8114A-02B

S E R V I C E N O T E

8114A 100 V / 2 A Programmable Pulse Generator

**Intermittent display failures
(shifting lines, inverted, fully lit or completely dark display)**

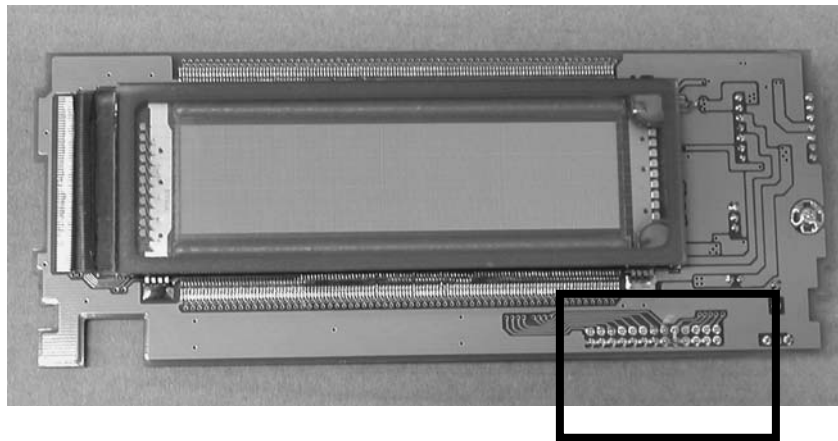
Intermittently the front panel display may show shifting lines that are falling back to their normal state. Additionally an inverted display, a display with all pixels lighted or a blank display may occur intermittently.

- Remove the front frame and unplug the connector cable from the 8114A mainframe.
- Carefully remove the display module from the front frame and check for a capacitor that might have been added during an earlier intermittent modification (see picture below). If there is such a capacitor, unsolder it from the module. Re-install the display into the front frame.

- Replace the flat ribbon cable that connects the display with the RPG board with the Display Adapter, p/n 81110-66555. Use the provided insulated clamp to secure the adapter board on the display connector.
